Wellington Lane Cycle Scheme

Stage 1 Road Safety Audit

Document Ref:	P22-106-RSA-PD-RP-001
----------------------	------------------------------

Location: Drawing 180201-1004 (P0) – Wellington Lane

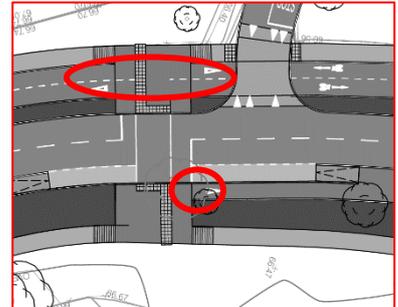
Summary: Visually impaired pedestrians may inadvertently enter cycle lane

No tramline tactile paving has been shown within the cycle lanes at their interface with the shared surfaces at the proposed toucan crossing. This could result in visually impaired pedestrians inadvertently entering the cycleway, and from there entering the carriageway.

Ladder and Tramline tactile paving should be provided at the cycle track ramps at the interface with footpaths, ensuring the correct tactile paving specification (i.e. flat-topped cycle way paving) is used.

Location: Drawing 180201-1005 (P0) - Orwell Road Roundabout

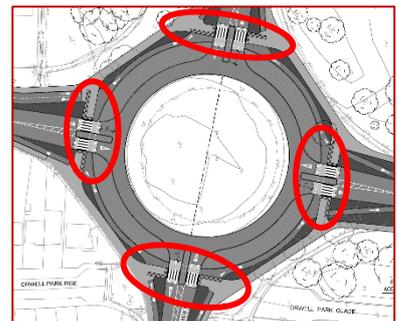
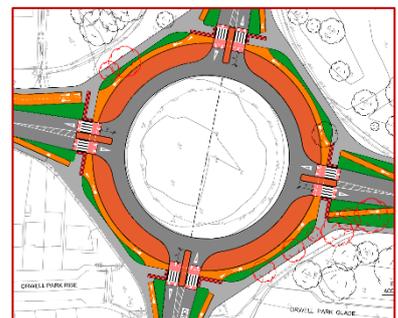
Summary: Visually impaired pedestrians may inadvertently enter cycle lane

The cycle tracks on the approaches to the Osprey Road, Wellington Lane/Road and Orwell Road roundabout cross footpaths, or run adjacent to the footpath and share the raised-table at the proposed zebra crossings.

No Ladder & Tramline tactile paving has been indicated to warn visually impaired pedestrians of the cycle tracks and it is unclear if vertical separation can be maintained as the footpath and cycle track share the raised-table crossings.

This could result in visually impaired pedestrians inadvertently entering the cycleway, and from there entering the carriageway.

The cycle track and footpath should be segregated vertically and laterally at the roundabout.

Location: Drawing 180201-1005 (P0) - Orwell Road Roundabout

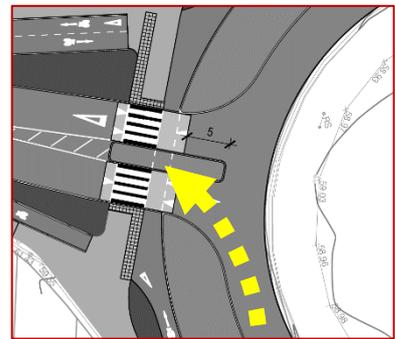
Summary: Amendments to roundabout may not achieve sufficient speed reductions if not of an appropriate form.

It is unclear what form the proposed carriageway width reduction on the roundabout circulating carriageway will take. It is assumed that it will consist of kerbed build-outs.

However, if non-physical means (e.g. road markings) were intended then this arrangement is unlikely to achieve sufficient speed-reduction on the approaches to the exits from the roundabout and the zebra crossings at these locations, possibly resulting in overshoot into the crossings and vehicle/pedestrian collisions.

The changes to the roundabout circulating carriageway should be of a form which ensures that vehicle speeds are sufficiently reduced to allow drivers to safely come to a halt when required to do so.

Location: Drawing 180201-1005 (P0) - Orwell Road Roundabout

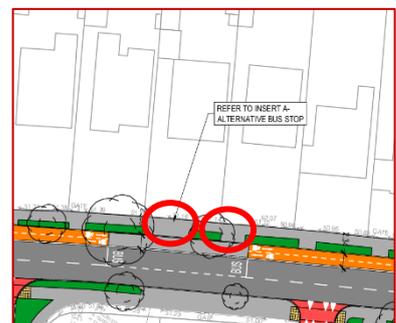
Summary: It is unclear if large vehicles will be sufficiently able to enter/exit the roundabout without overhanging the waiting area at the crossings.

Information regarding the swept path of large vehicles (buses, refuse trucks etc.) has not been provided to the Audit Team. It is therefore unclear if these vehicles will have sufficient space on the entry to & exit from the circulating carriageway within the roundabout without overhanging footpaths.

The lane width & geometry on the entry to & exit from the circulating carriageway is such that it may be overrun, or portions of large vehicles could overhang into the pedestrian refuge island, or on the approach to the crossings, presenting a possible hazard to pedestrians.

Ensure the entry/exit at the roundabout have sufficient width to allow for the overhang of the larger vehicles, in particular buses.

Location: Drawing 180201-1010 (P0) – Whitehall Road.

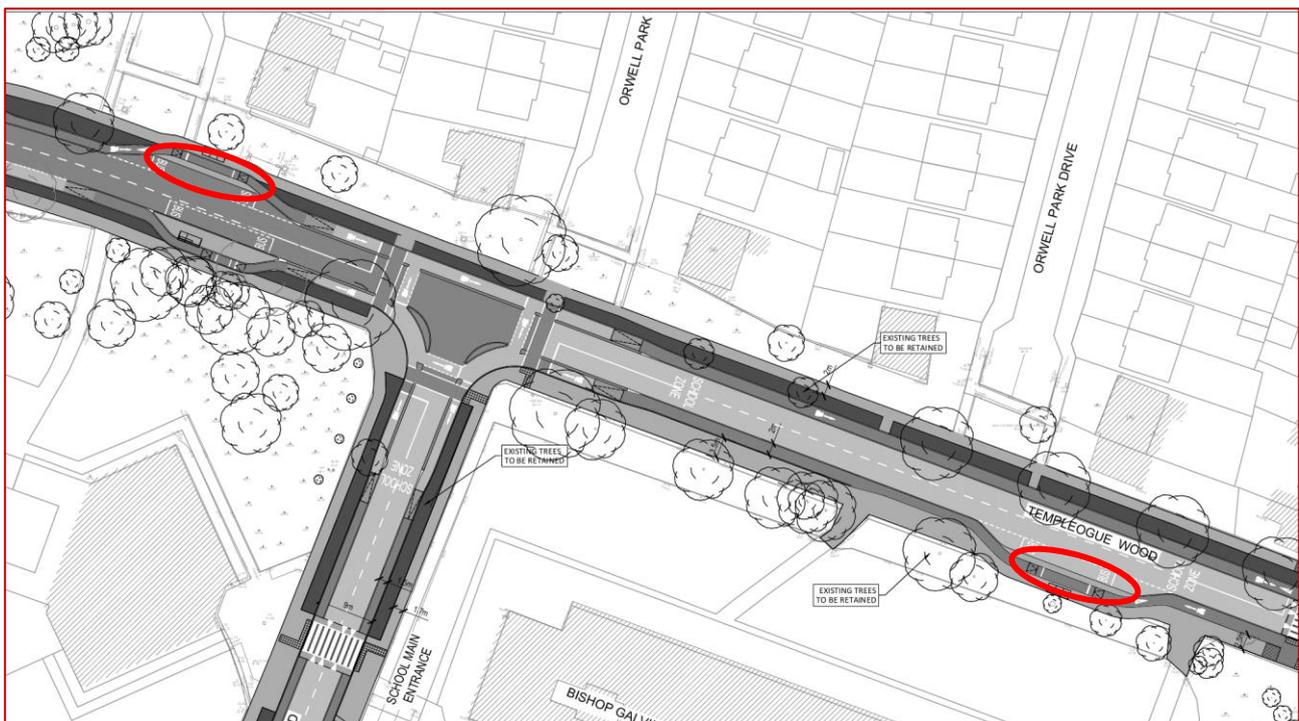
Summary: Visually impaired pedestrians may inadvertently enter cycle lane.

It is proposed to provide an ‘Alternative Bus Stop’ layout at two locations along the northern side of Whitehall Road where the two-way cycle lanes are proposed.

The proposed Alternative Bus Stop layout does not include Ladder & Tramline tactile paving on the entry to the shared pedestrian/cyclist area at the bus stop, possibly resulting in visually impaired pedestrians inadvertently entering the cycle track via the transition to the cycle ramp.

Provide Ladder and Tramline tactile paving at the interface between the shared surface, the footpath and the cycle tracks.

Location: Drawing 180201-1051 (-) – Orwell Road and Templeogue Wood

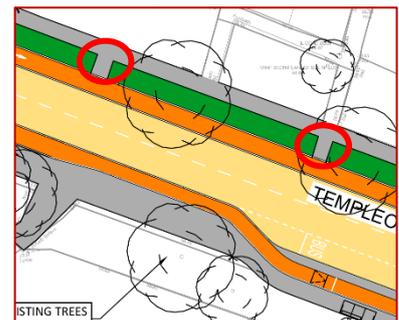
Summary: Retained footpath links at Templeogue Wood may encourage informal crossing and increase risk of pedestrians tripping and falling.

Footpath links have been indicated from the footpath on the northern side of Templeogue Wood to the kerb at the cycle track. This arrangement is likely to encourage pedestrians to cross at these locations, however with no gaps provided in the protected cycle lane kerbs at these locations there is a risk of pedestrians tripping and falling.

Remove the footpath links to encourage crossing at the proposed controlled crossings.

Location: General Problem

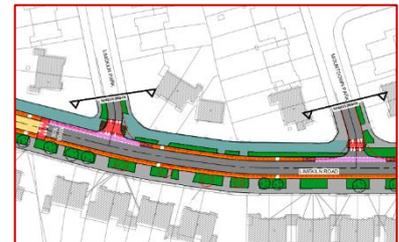
Summary: Tactile paving stem does not extend to/beyond the walking path line

At several locations where controlled crossings are proposed at signalised junctions the tactile paving stem does not extend to the back of the footpath. As a result, visually impaired pedestrians may not be able to locate the tactile paving and consequently the crossing point itself.

Tactile paving should extend to the back of the footpath all controlled crossings, or a sufficient distance so as to be encountered by visually impaired pedestrians on the approaching paths.

Location: Drawing 180201-1008 (P0) - Whitehall Road

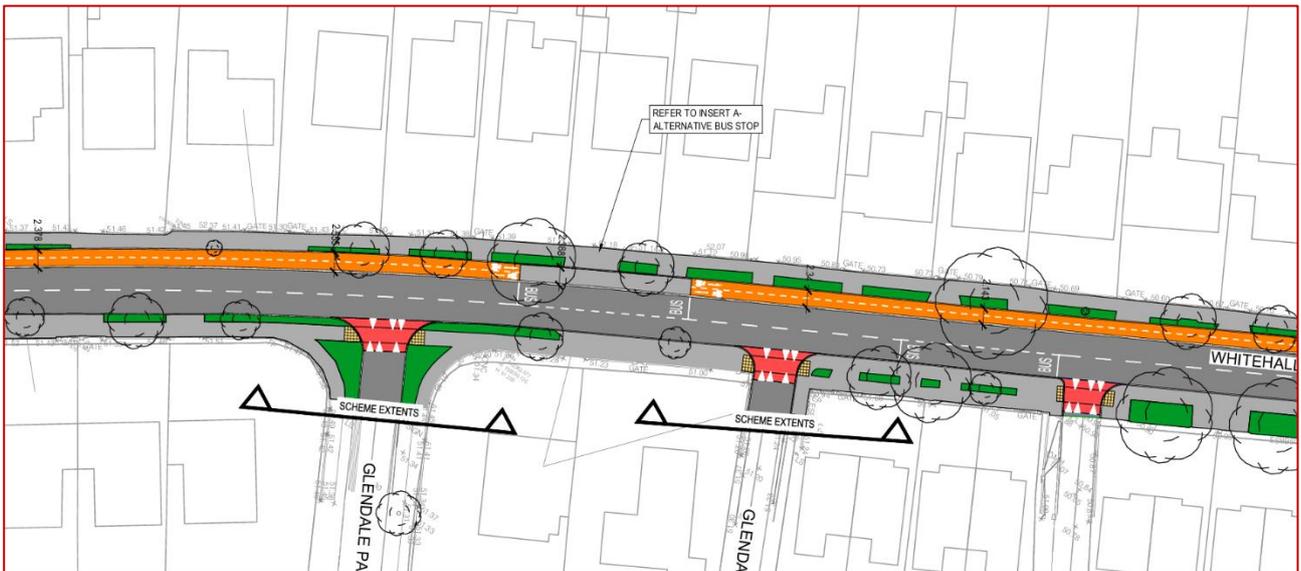
Summary: Position of dropped kerbs on the corner of the junction could result in inappropriate/unsafe crossings.

The position of the uncontrolled pedestrian crossing of Whitehall Road West, on the corner of its junction with Whitehall Road, could result in southbound pedestrians travelling along the eastern side of Whitehall Road mistaking the tactile paving and dropped kerb as indicating a crossing of Whitehall Road at a location where crossings are not intended, and where drivers may not expect a pedestrian to cross, leading to unsafe/inappropriate crossings.

The location of the uncontrolled pedestrian crossing should be adjusted so that the direction of the crossing is clear to approaching pedestrians.

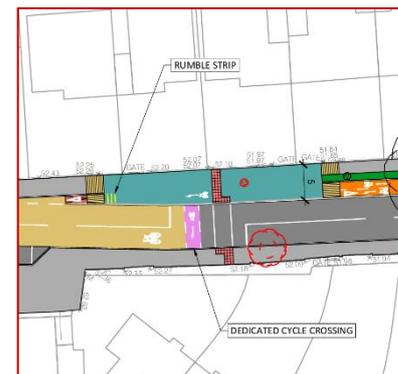
4.2 It is unclear if straight-ahead cyclists at the proposed signalised protected-junctions (e.g. at Wellington Green) are to proceed at the same time as traffic in the same direction of travel.

The offset of the cycle lane along the intersecting road, away from the through traffic in the same direction of travel as the cyclists could result in turning drivers believing that cyclists are at a crossing, and should give way to turning traffic.

To avoid potential confusion cyclists should have a separate traffic signal phase to vehicular traffic within these junctions.

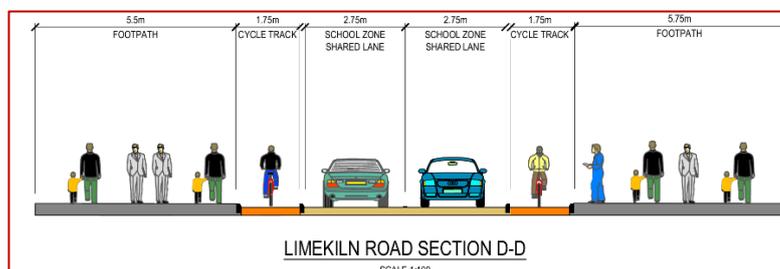
4.3 It is unclear if it is intended to provide a dropped-kerb at the dedicated cycle crossing of Whitehall Road. It is likely that some form of dropped-kerb would be considered necessary to facilitate cyclists use of the crossing. However, a dropped kerb raises the risk of visually-impaired pedestrian inadvertently straying into the carriageway, where they are at risk of being struck by a vehicle. All dropped kerbs should have a minimum upstand of 25 mm, or else tactile paving should be provided.

Alternatively amend the proposed arrangement such that the proposed pedestrian crossing and dedicated cycle crossing combined into a single toucan crossing.
